STATEMENT OF WORK for CONSTRUCTION SERVICES
Office/Maintenance Facility
At
Bon Secour National Wildlife Refuge
(Approximately at 30.2526, -87.8133)
South Atlantic-Gulf & Mississippi Basin Region

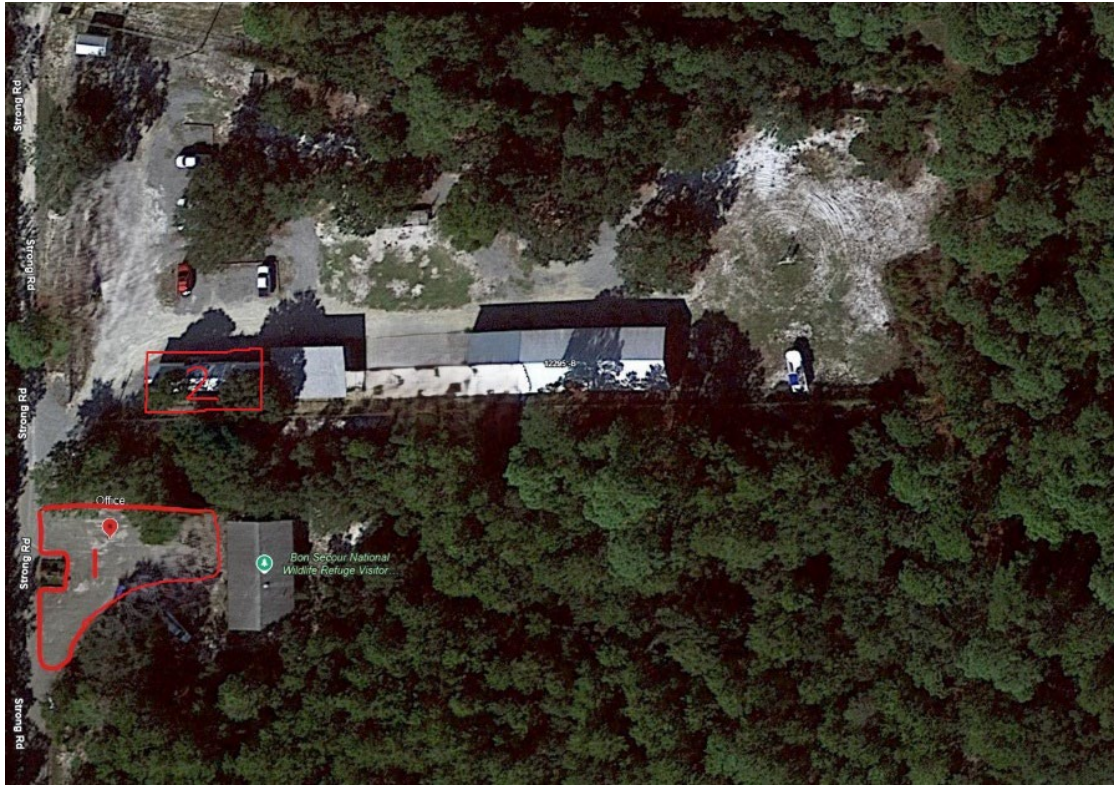
14. Can you please confirm if there will be designated lay down areas for contractor operations?

USFWS Response- We can use the existing parking lot (1) and footprint of former mobile maintenance trailer (2) for staging areas and materials and keep Strong road open for public traffic. We need to maintain an 8 foot wide access to the existing headquarters in the parking lot. Please also note that when existing maintenance yard is removed, a temporary fence must be installed as per the requirements in the construction drawings (GENERAL, SHEET 2 OF 91, G-002, PART 15) and in specifications 01 50 00 Temporary Facilities and Controls, 10 71 33, Protection of Work and Property.

20. Please provide location staging area(s) will be allowed/designated?
USFWS Response We can use the existing parking lot (1) and footprint of former mobile maintenance trailer (2) for staging areas and materials and keep Strong road open for public traffic. We need to maintain an 8 foot wide access to the existing headquarters in the parking lot. See aerial photo in response to question 14.
